ABC SUBDIVISION

APPLICATION NUMBER 13 DATE June 3, 2004

REQUEST Subdivision

ABC SUBDIVISION

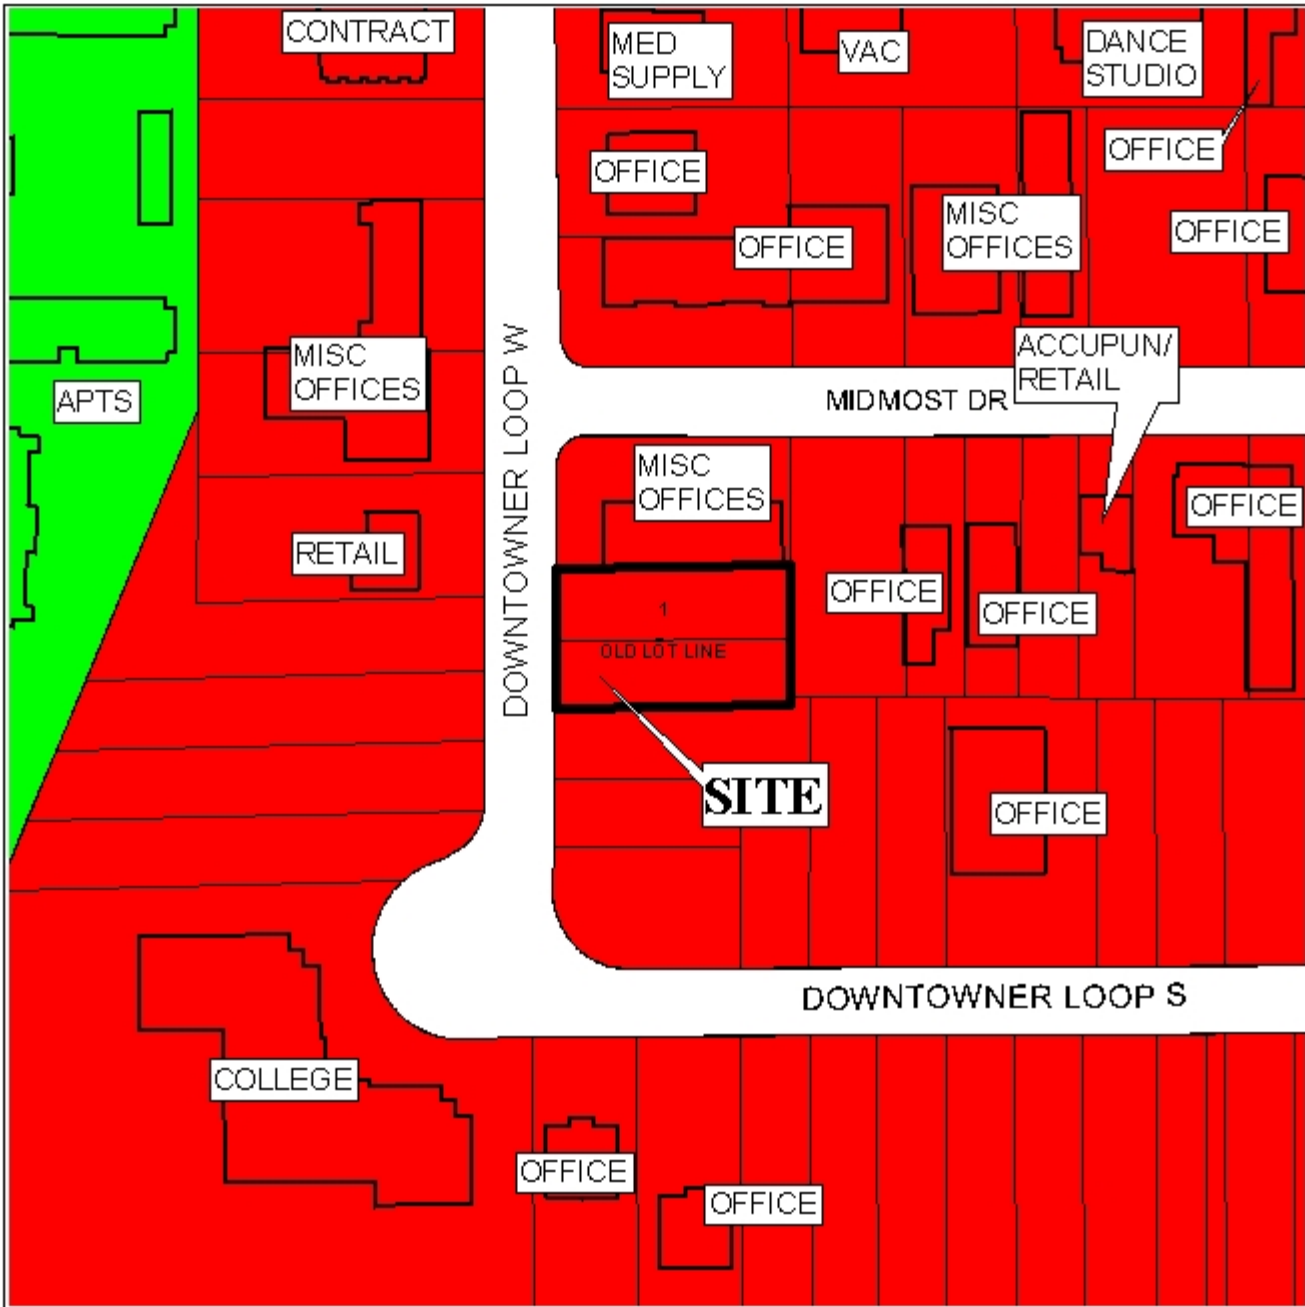
The 25-foot minimum building setback line is not shown but would be required on the final plat.

The plat meets the minimum requirements of the Subdivision Regulations and is recommended for Tentative Approval subject to the following condition: 1) the placement of the 25-foot minimum setback line on the final plat.
